New High School in Bungendore

State Significant
Development Application
(SSD-14394209)

Architectural + Landscape Design Report Addendum

Rev B
September 2022
Project No. 200096

6 Reinstatement of the Majara Street Alignment

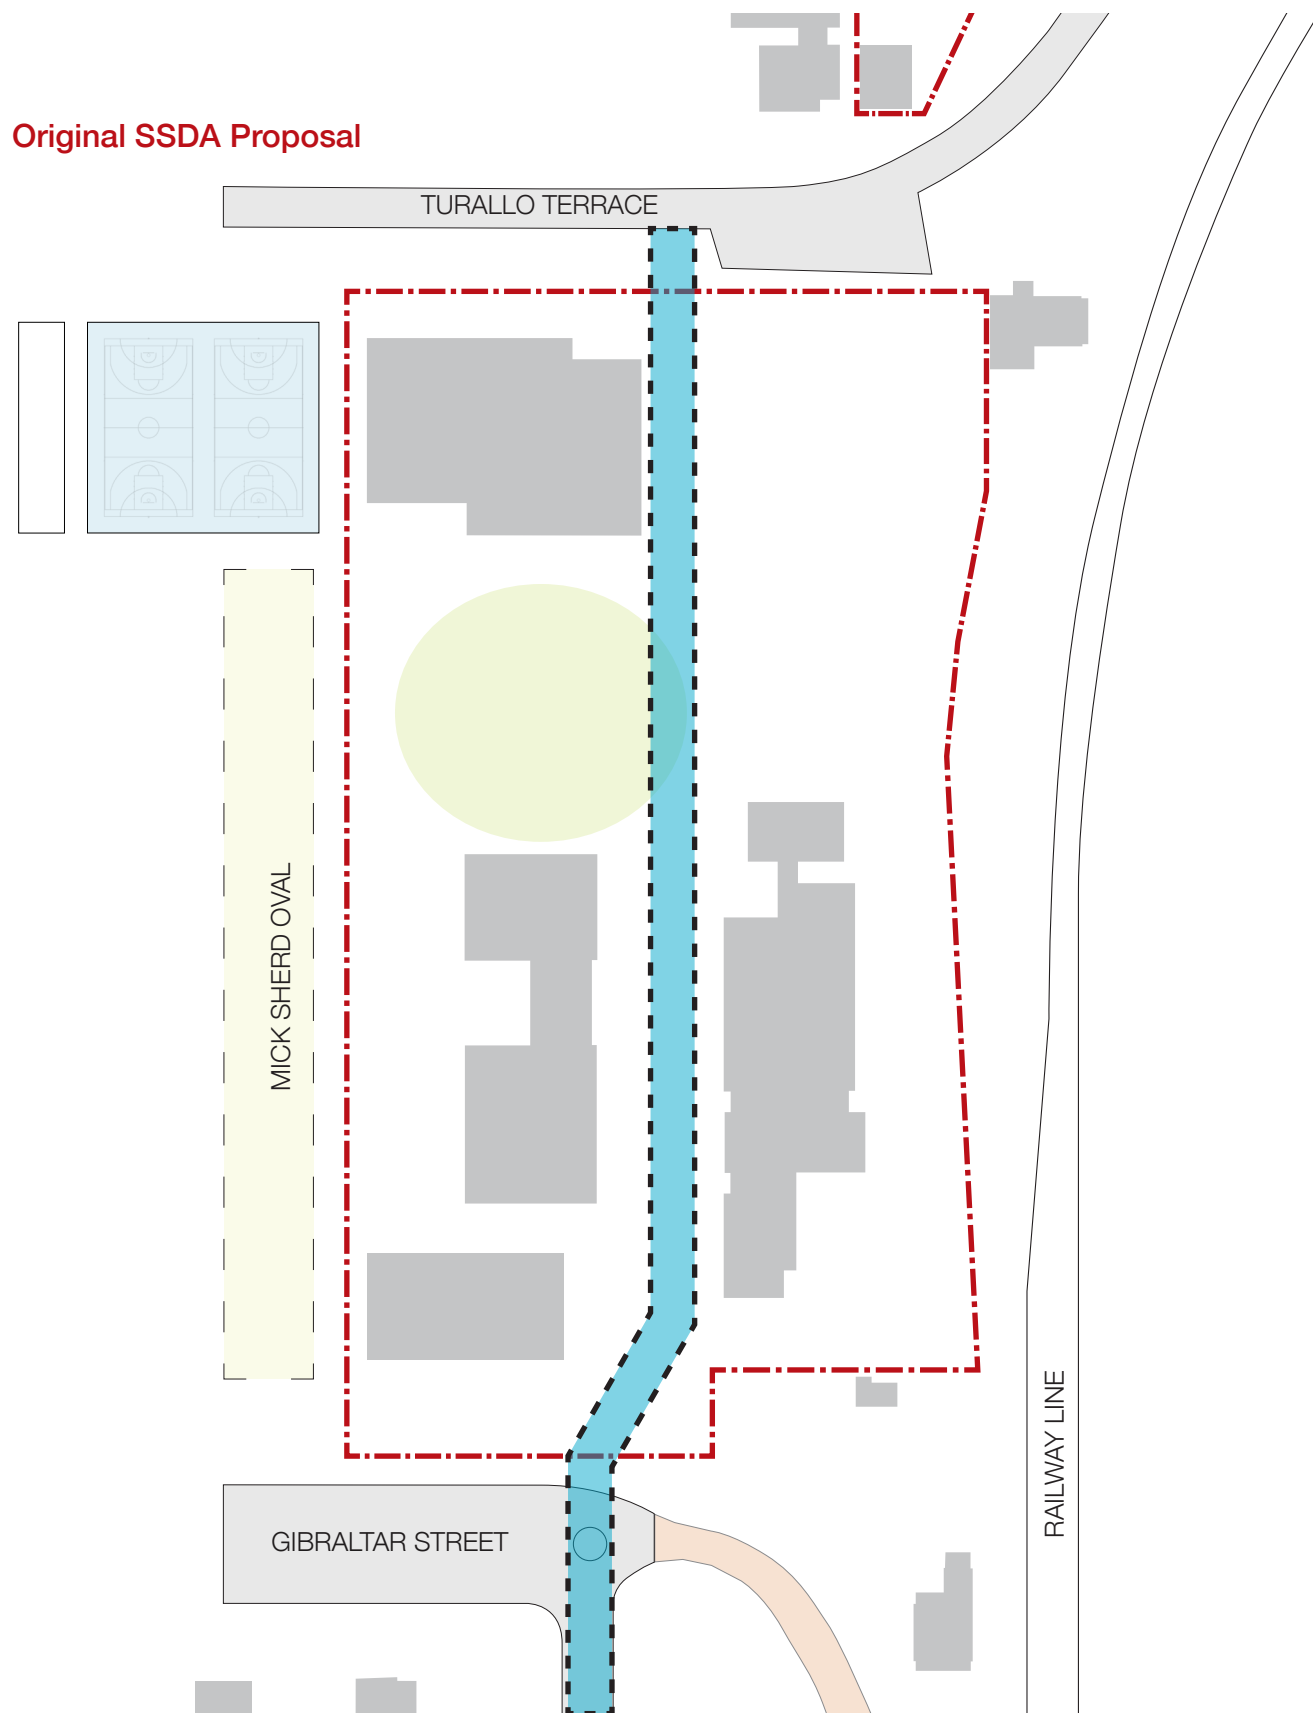
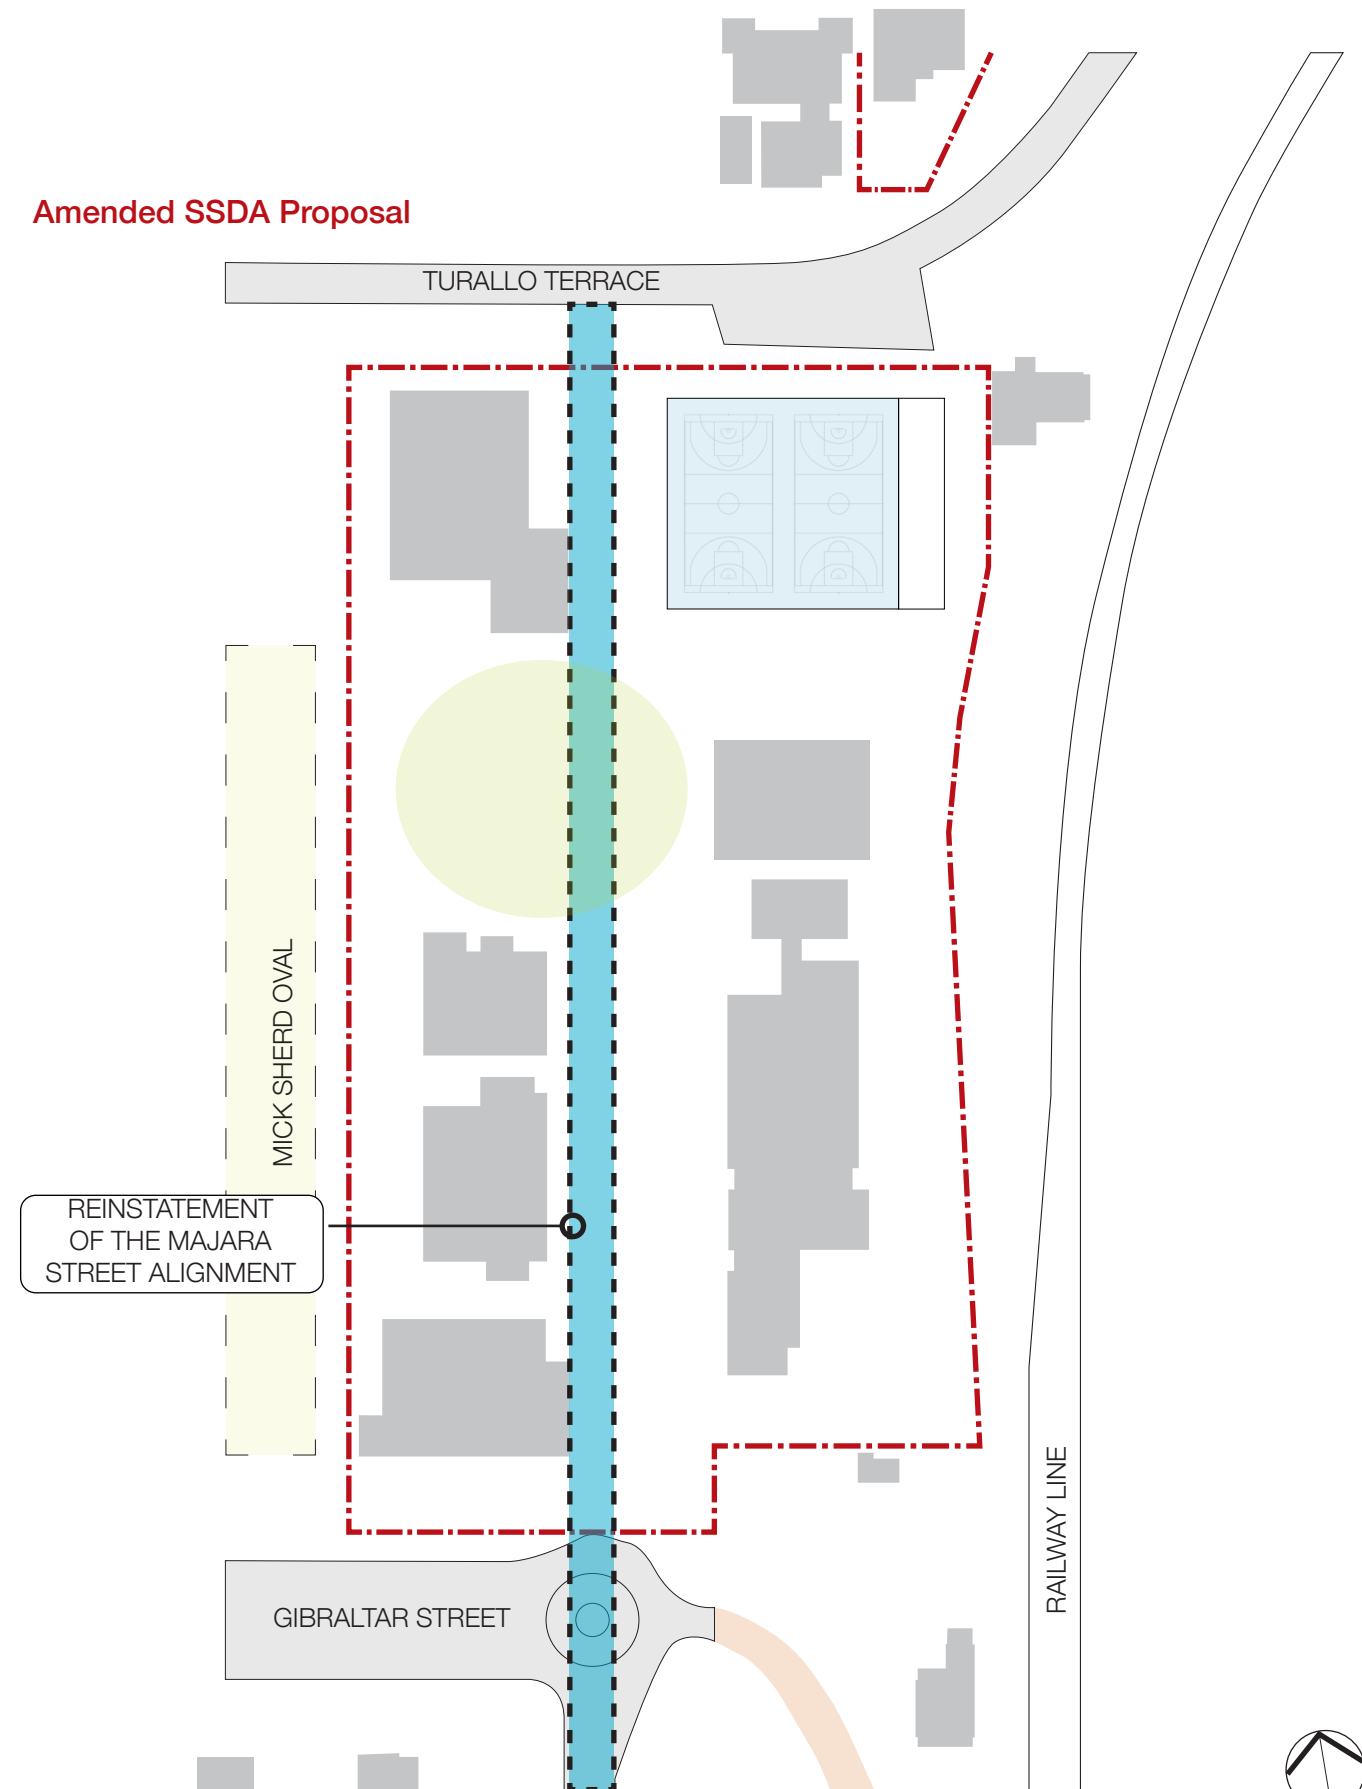
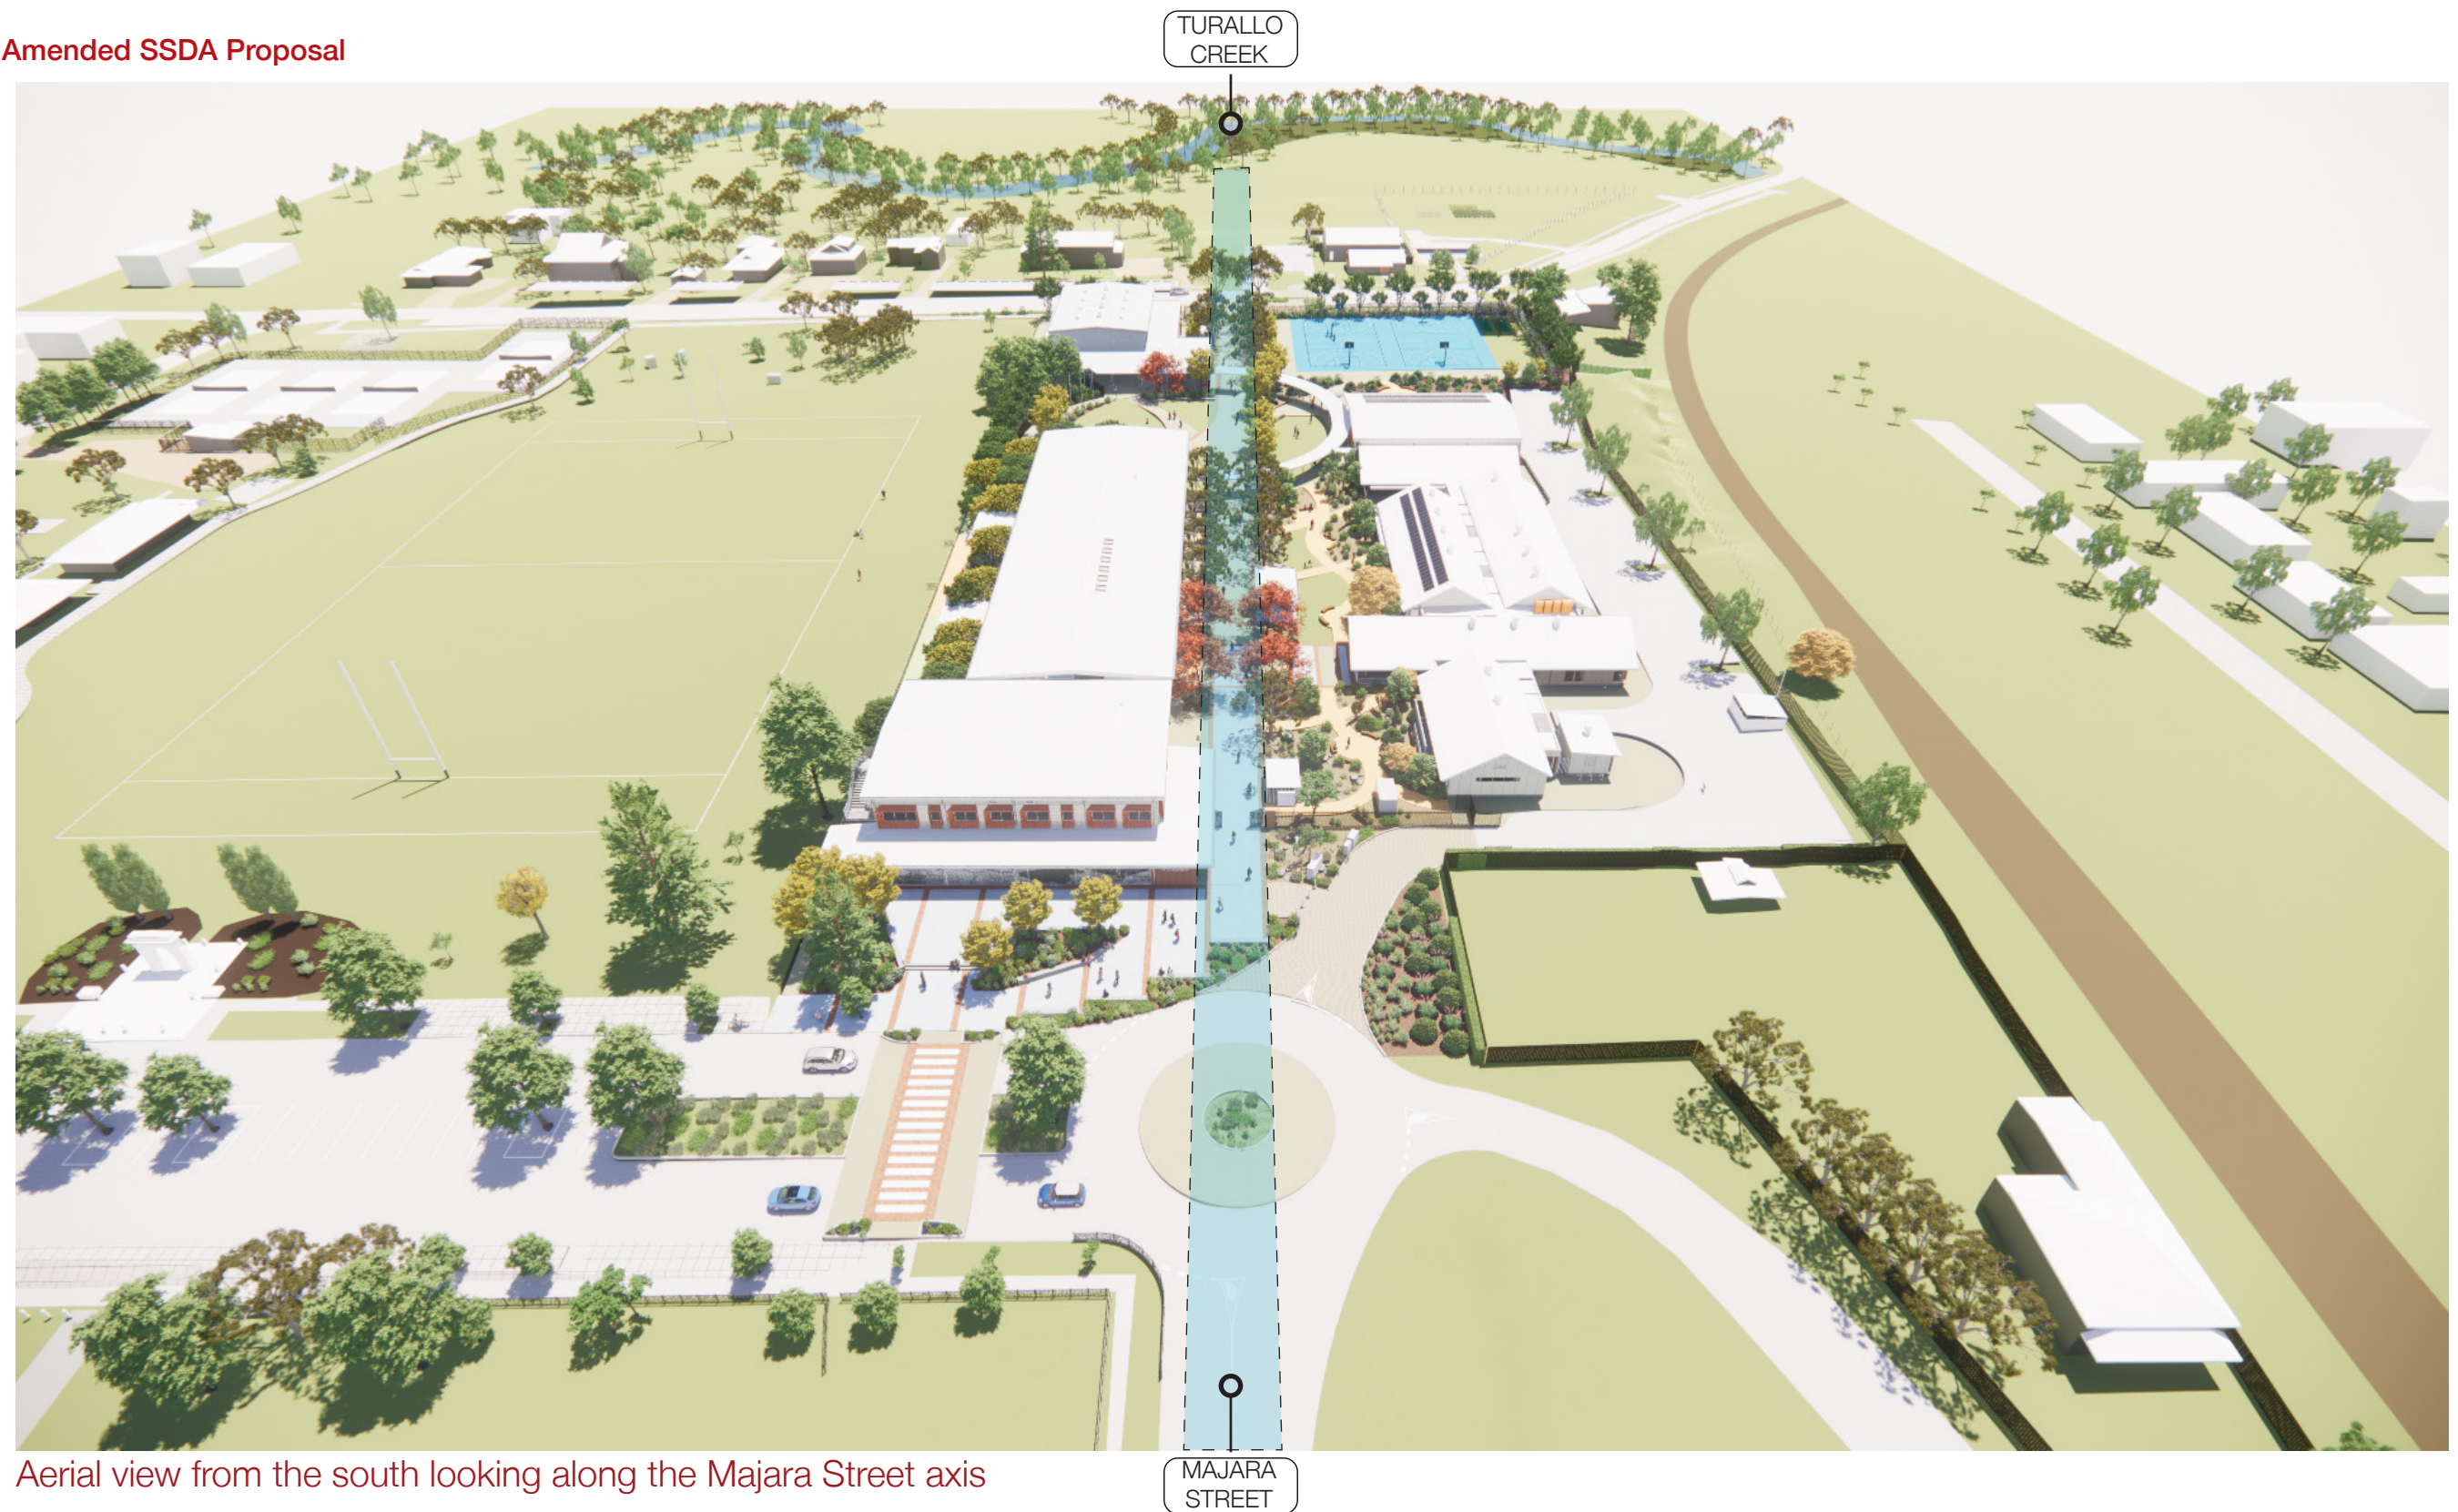
The Majara Street alignment has been reinstated through the relocation of the School Library, the redesign of Block D and the relocation of Block B.
